HUNTS POINT INTERSTATE ACCESS IMPROVEMENT PROJECT – CONTRACT 3

PIN X731.65, Contract D900055

Addendum #8

July 22, 2022

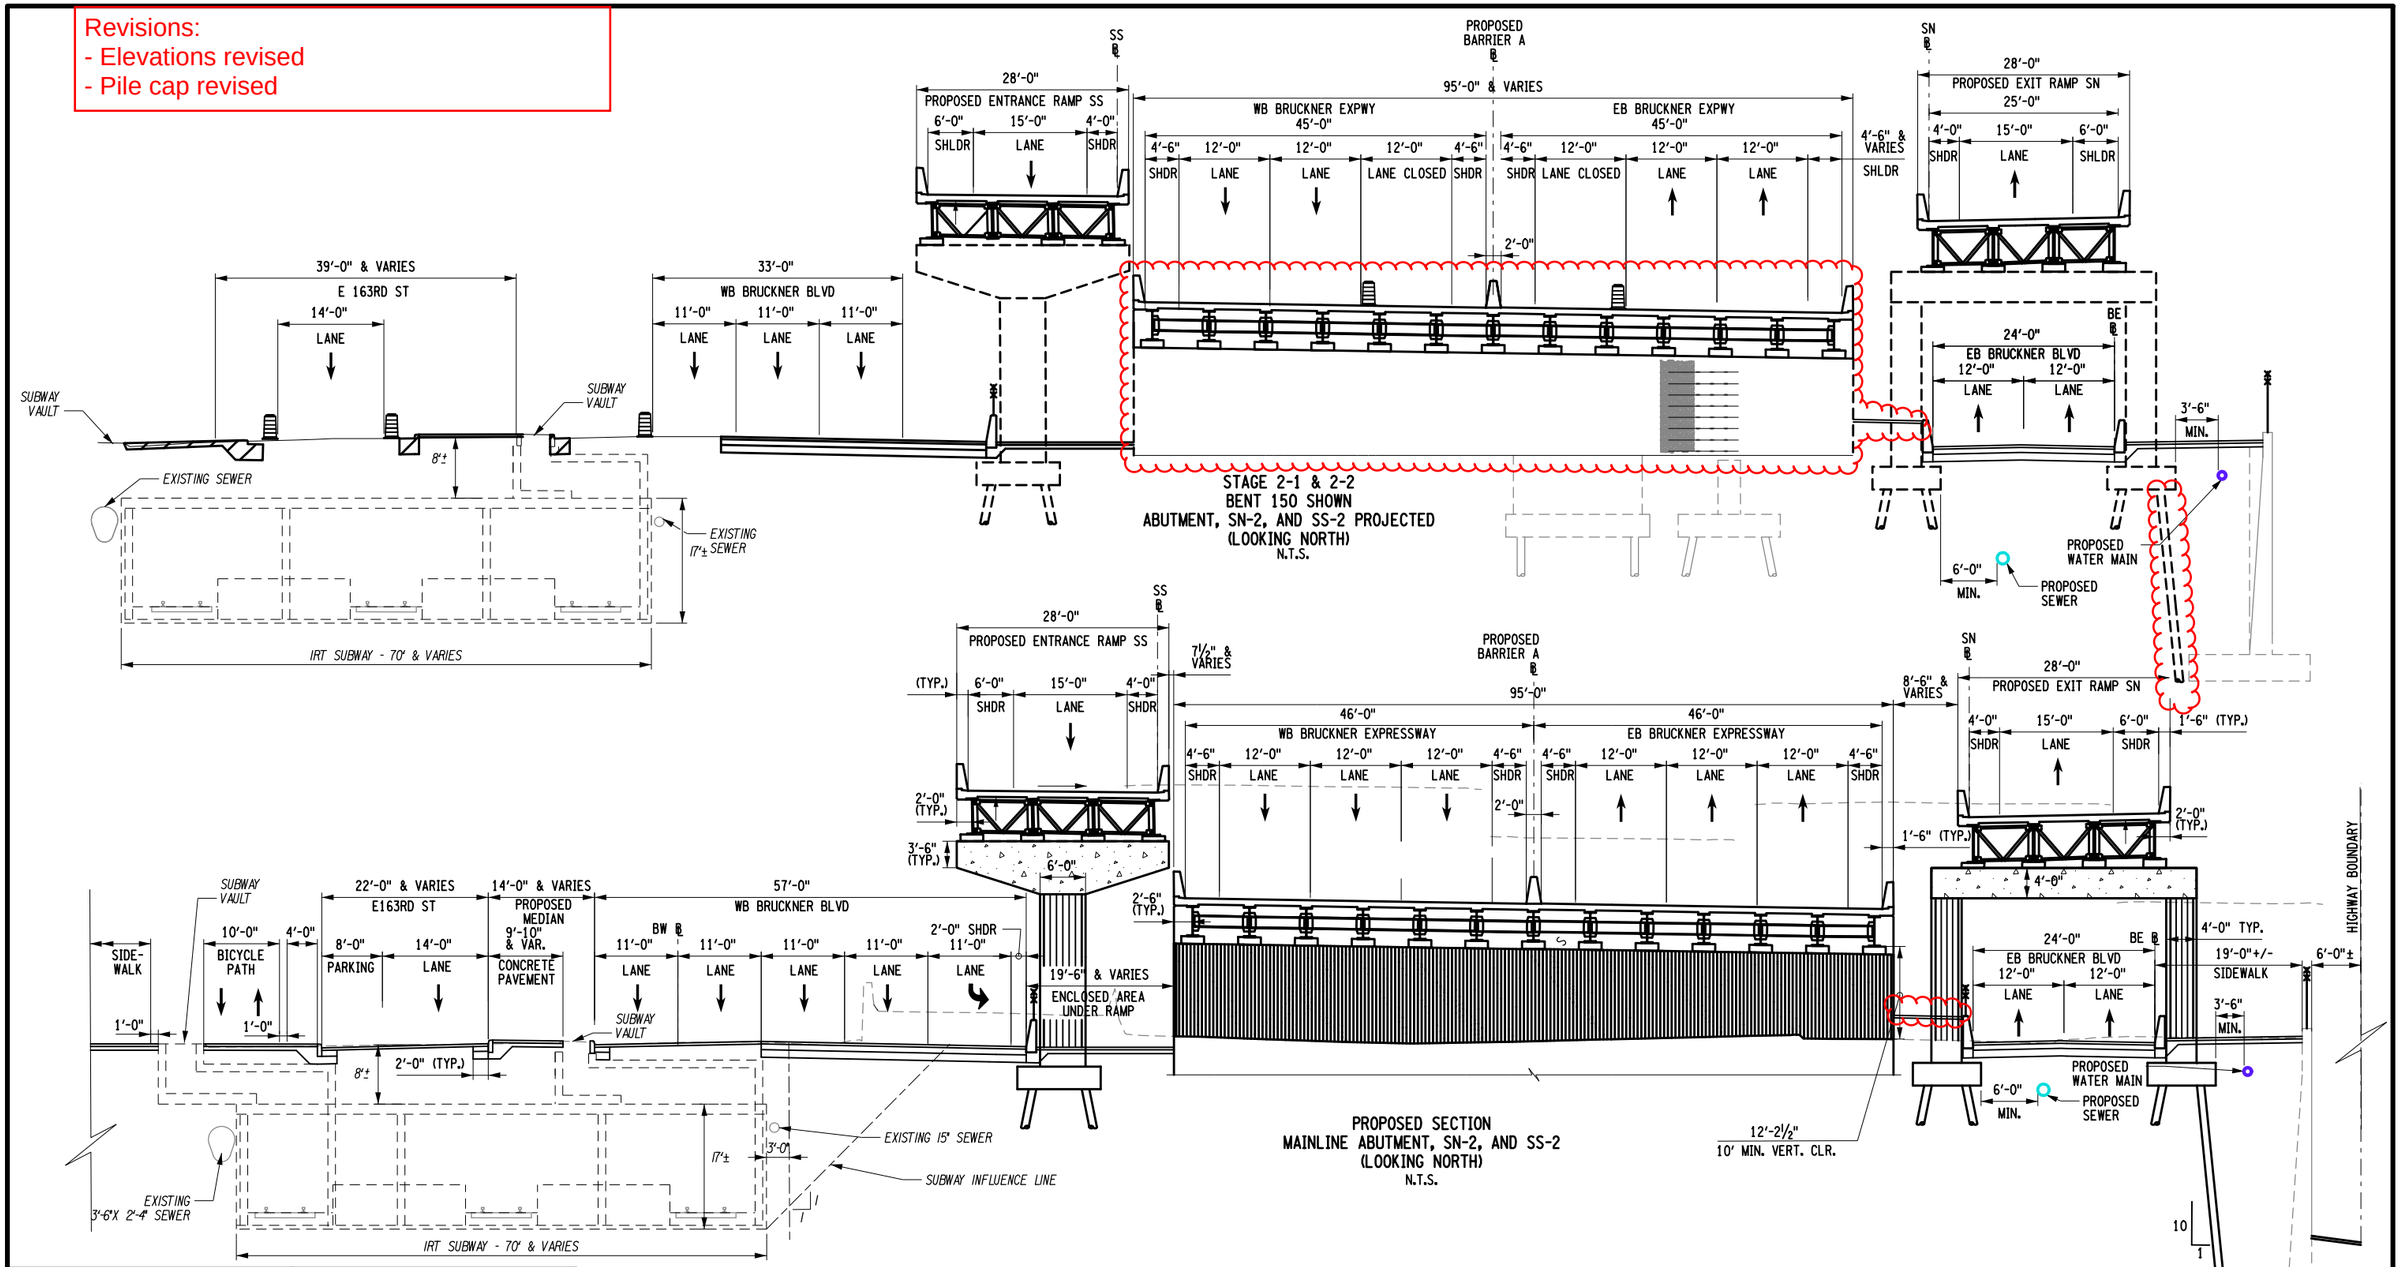
Revisions:
- Elevations revised
- Pile cap revised

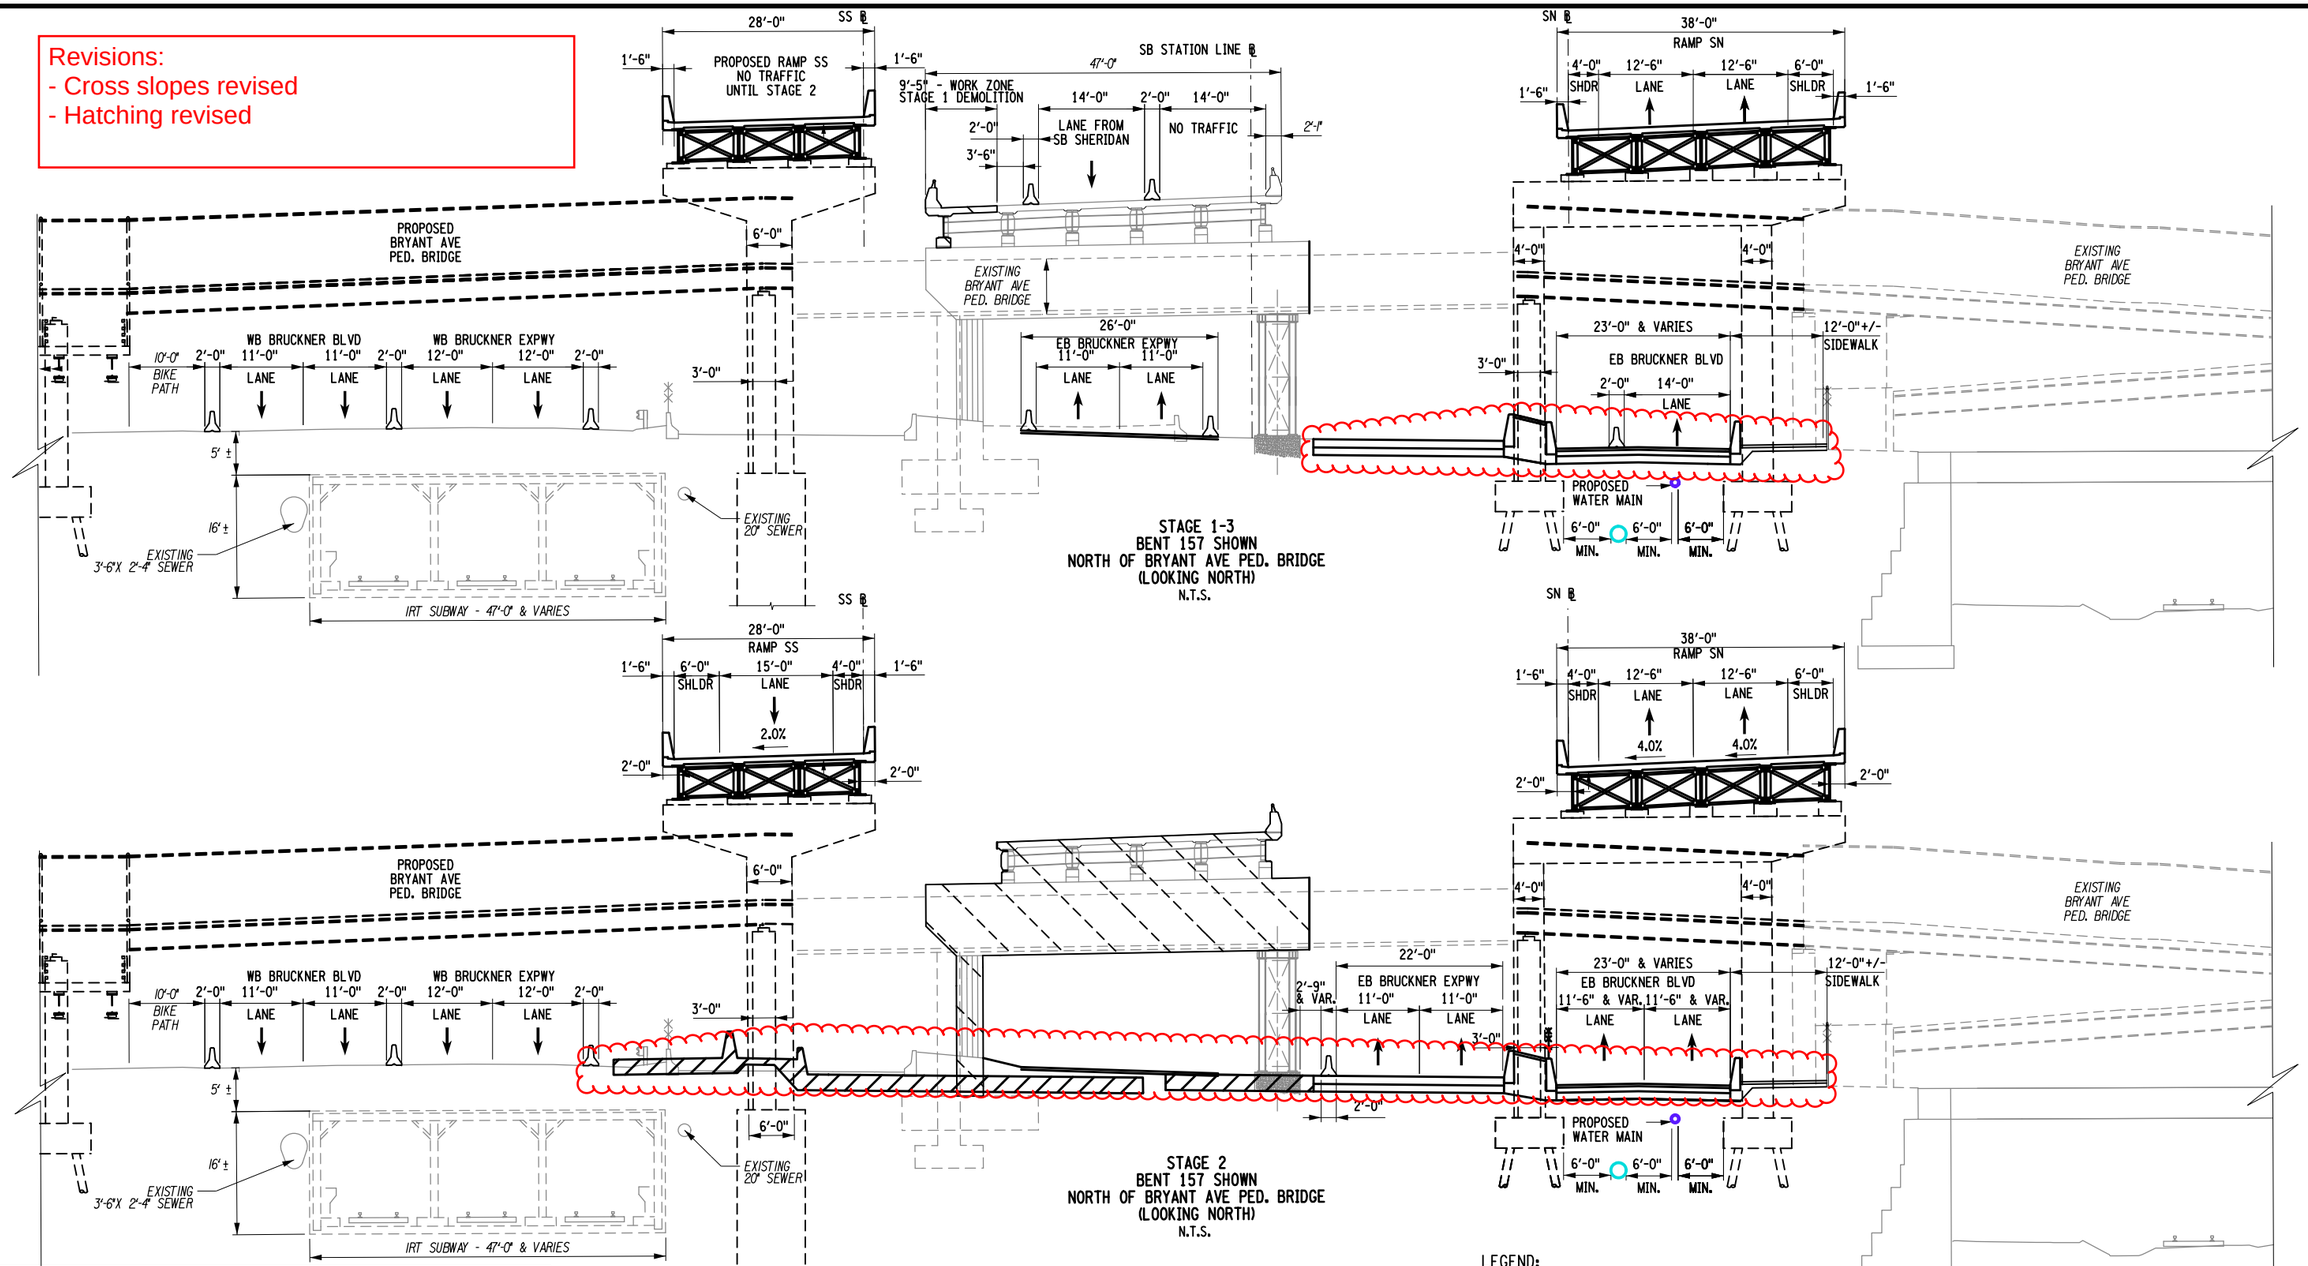
Revisions:
- Cross slopes revised
- Hatching revised

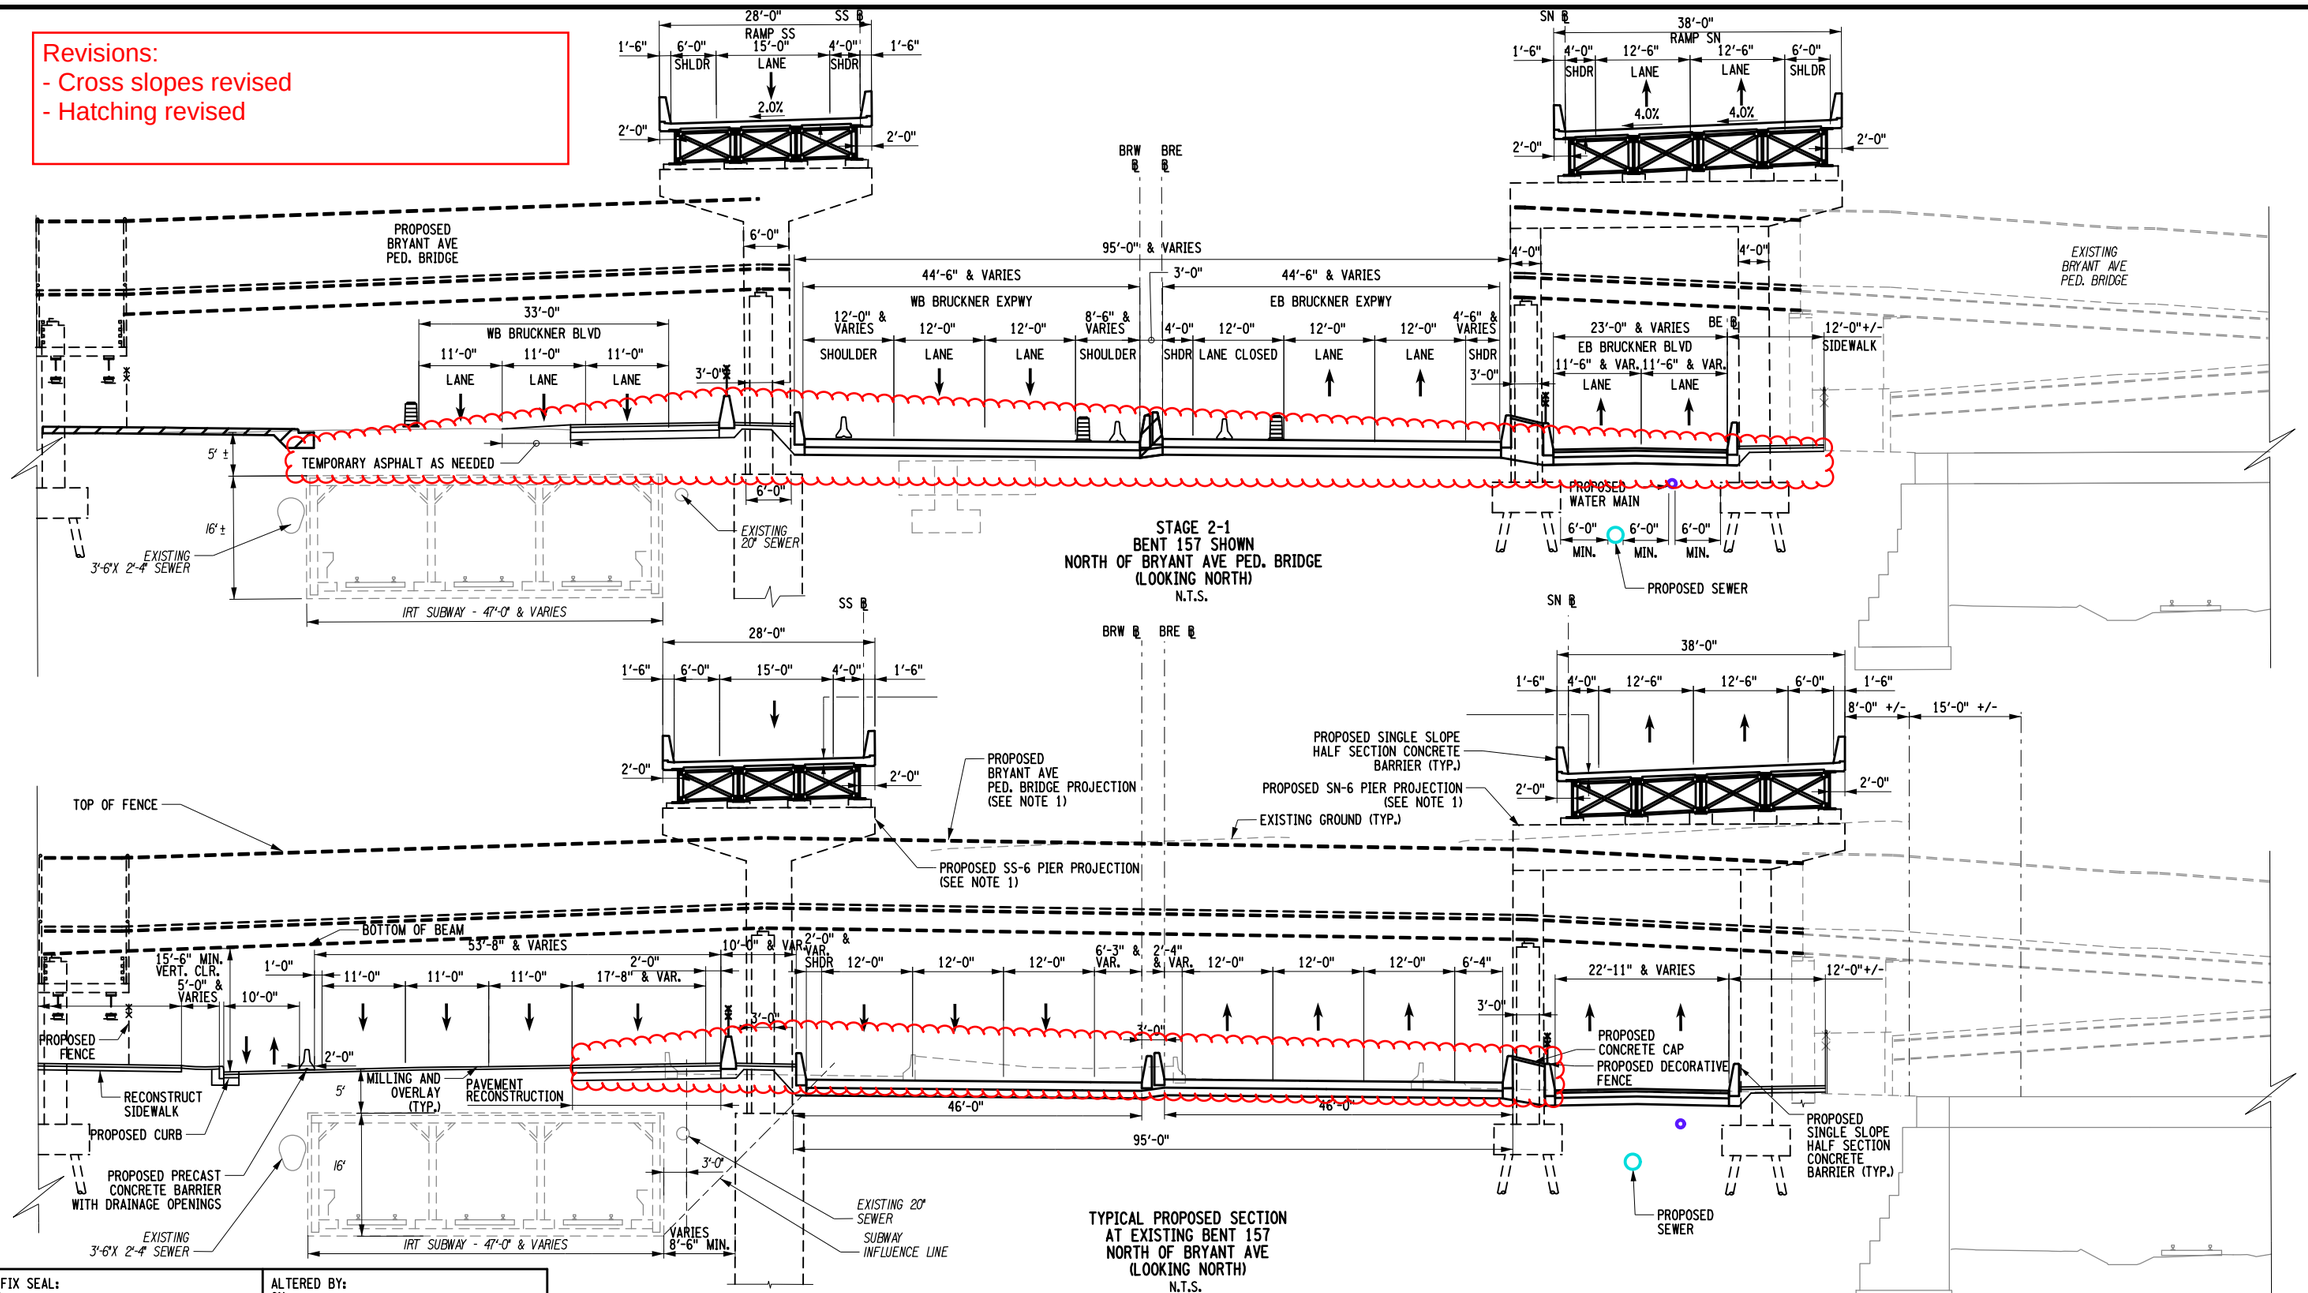
Revisions:
- Cross slopes revised
- Hatching revised
